United States Patent and Trademark Office

APPLICATION NO.	FILING DATE	FIRST NAMED INVENTOR	ATTORNEY DOCKET NO.	CONFIRMATION NO.
08/650,719	05/20/1996	JEFFREY S. MAILLOUX	95-0653	2941
21186 7590 02/20/2007 SCHWEGMAN, LUNDBERG, WOESSNER & KLUTH, P.A. P.O. BOX 2938 MINNEAPOLIS, MN 55402			EXAMINER	
			KIM, HONG CHONG	
			ART UNIT	PAPER NUMBER
			2185	
SHORTENED STATUTORY	PERIOD OF RESPONSE	MAIL DATE	DELIVERY MODE	
3 MON	THS	02/20/2007	PAPER

Detailed Action

FIG. 17

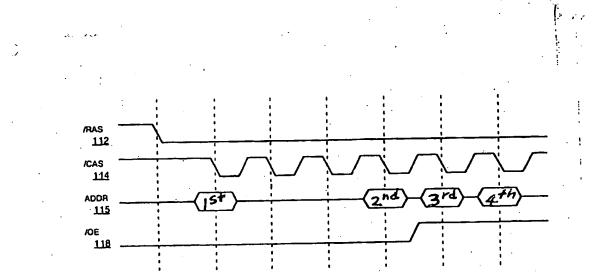
6. Claim 61 is rejected under 35 U.S.C. 112, first paragraph, as failing to comply with the written description requirement. The claim(s) contains subject matter, which was not described in the specification in such a way as to reasonably convey to one skilled in the relevant art that the inventor(s), at the time the application was filed, had possession of the claimed invention. Because although the specification (pg.27, 1-11; pg.38, line 11-15; and pg. 39, lines 9-16) describes burst and pipeline operations as pointed out by the applicants in the brief, the specification does not specifically describe claimed limitation of "providing an initial external address associated with asynchronously accessing the asynchronously-accessible memory device in the pipelined mode of operation", "switching mode to a burst mode of operation", "while in the burst mode of operation, generating at least one subsequent internal address patterned after the initial external address provided while in the pipelined mode of operation", and "providing a new external addresses for every access associated with accessing the asynchronously-accessible memory device while in the burst mode of operation". This instant application describes "switching between burst EDO and pipelined EDO modes is accomplished on successive /CAS cycles" (Pg 38 lines 11-15

and See Fig. 17 Refs 114 and 115, each /CAS cycle represents a new column address in pipeline mode). In other words, a new external address (Fig. 17 3rd addr) is needed after the initial external address (Fig. 17 2nd addr) to switch modes (also refer to claim 46 of the present application), however, applicant claimed generating at least one subsequent internal address patterned without a new external address. Therefore, "providing an initial external address associated with asynchronously accessing the asynchronously-accessible memory device in the pipelined mode of operation". "switching mode to a burst mode of operation", "while in the burst mode of operation, generating at least one subsequent internal address patterned after the initial external address provided while in the pipelined mode of operation", and "providing a new external addresses for every access associated with accessing the asynchronouslyaccessible memory device while in the burst mode of operation" were not described in the specification. Again pg. 33, lines 13-21, pg 38, lines 11-15, and pg. 27, lines 5-11 of this instant application do not specifically disclose "while in the burst mode of operation, generating at least one subsequent internal address patterned after the initial external address provided while in the pipelined mode of operation".

8. Claim 61 would be allowable if rewritten or amended to overcome the rejection(s) under 35 U.S.C. 112, set forth in this Office action.
